# Pella® Recommendation for ENERGY STAR® Criteria Revision

# WDMA/DOE/LBNL Joint Meeting

ENERGY STAR 2009 Proposals

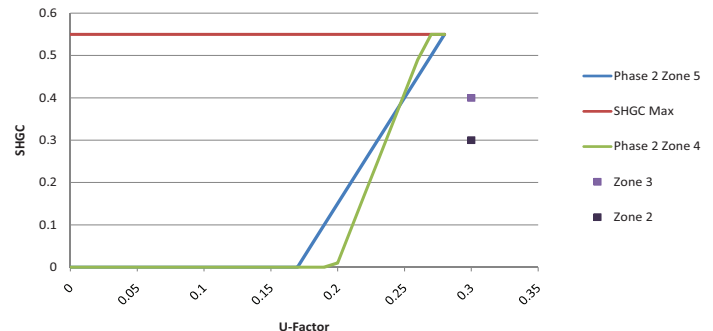
2. Combine Zones 4 and 5 into one zone, or another combination that is representative of climate and design temperatures.
  - a. There is little difference between the performance curves as proposed by DOE.

- b. Combining zones would be easier for consumer to understand.
  - c. The small difference between the performance curves as proposed by DOE for Zones 4 and 5 does not warrant the added consumer confusion. The same holds true for Zones 2 and 3 below.

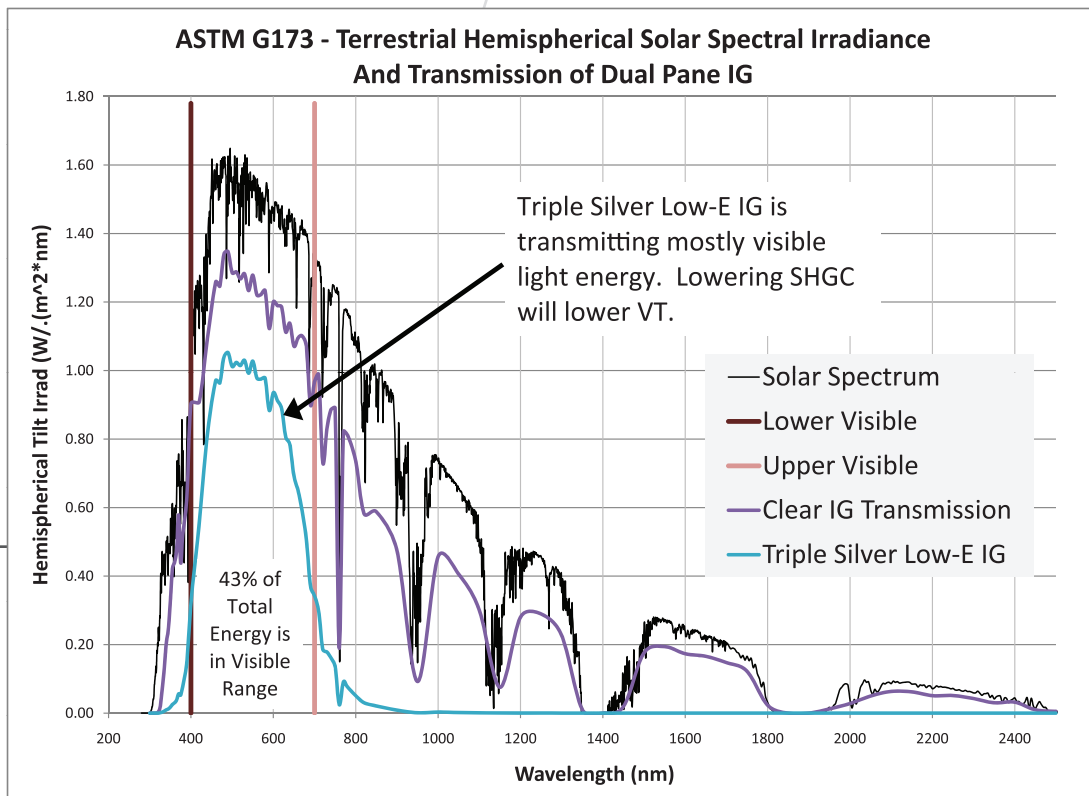
- e. Average Annual Whole House HVAC Costs by Zone (per Pella's Resfen5 analysis)
    - i. There is greater incremental savings from existing ENERGY STAR qualified products than there is from the existing criteria to proposed Phase 1 or 2. This combined with substantial price increases will make new ENERGY STAR windows less attractive to buy.

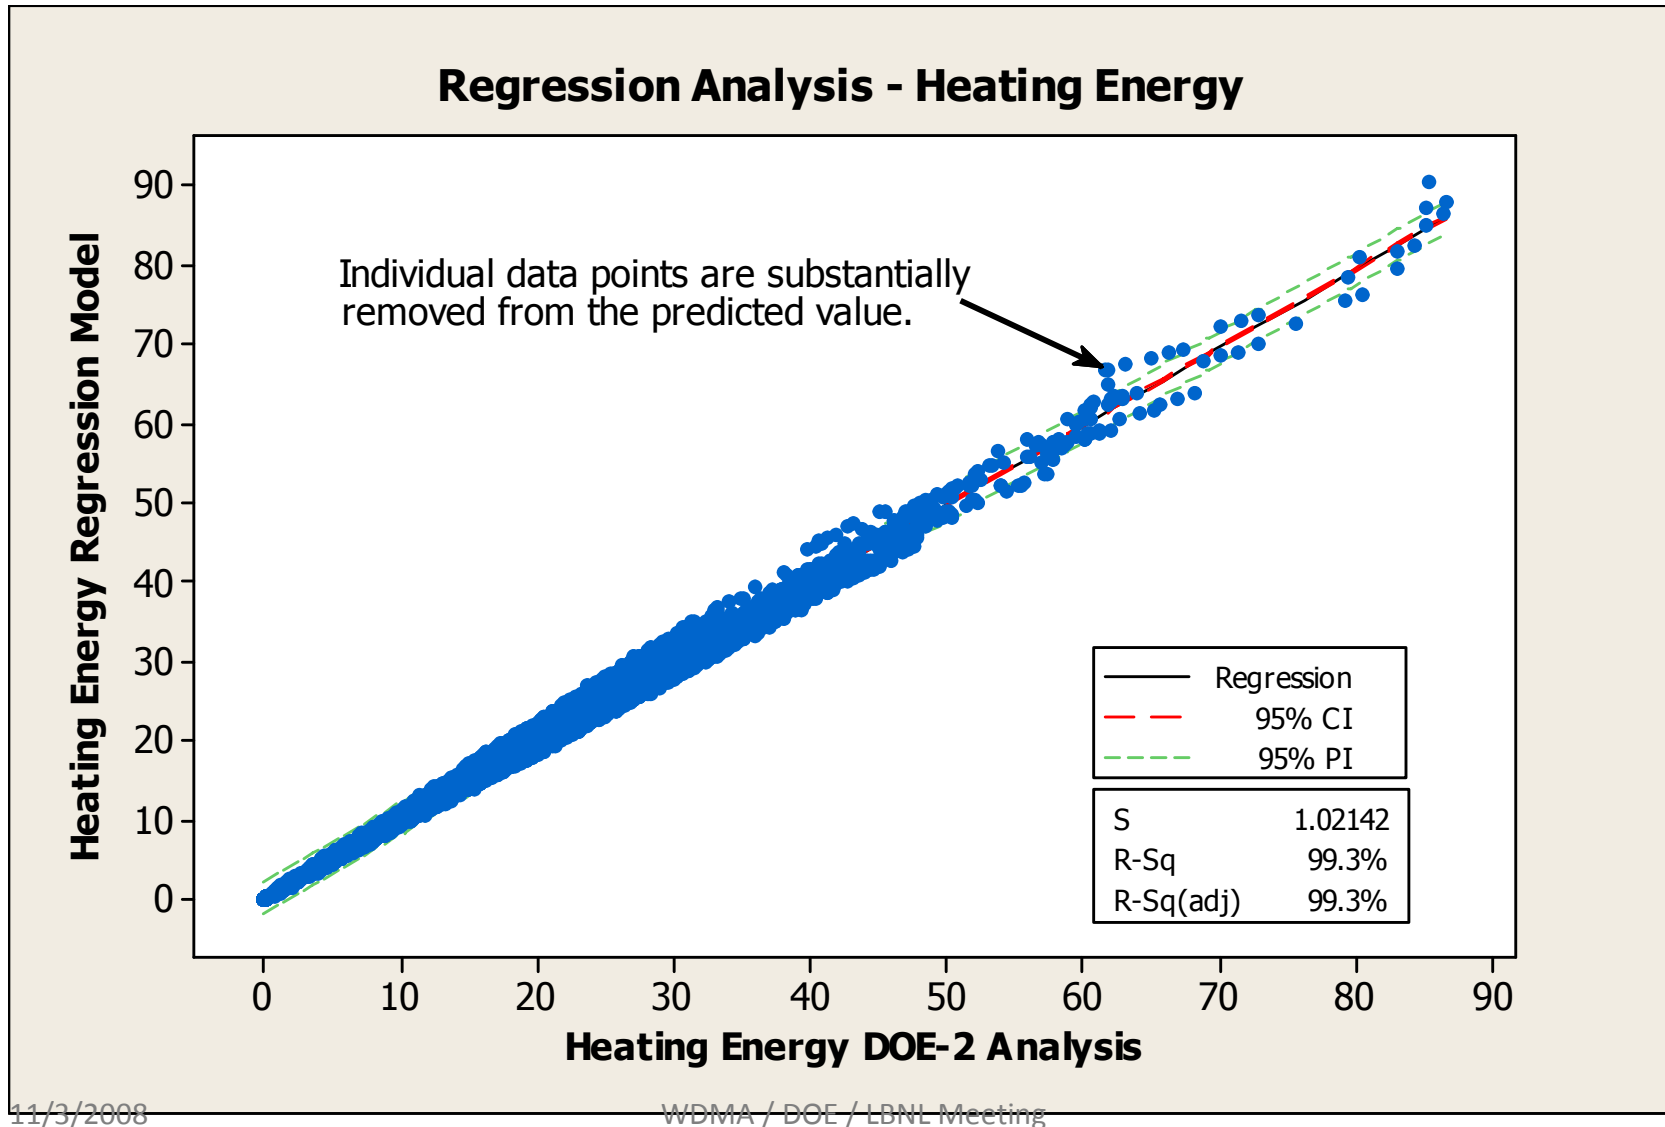
- Interior Shade Usage
  - Resfen suggests that interior shades are open 2/3 time in winter and closed 2/3 time in summer.
  - For homeowners, the motivation for blind usage is issue of privacy control, not energy savings.
  - Daylight hours in Northern latitudes suggests opposite response: dark for winter morning and daylight in summer morning
  - Do homeowners consciously open to the winter “dark” and close to the summer “light”?
  - Basing energy savings on variable SHGC, as affected by shading use, does not provide a sure result.
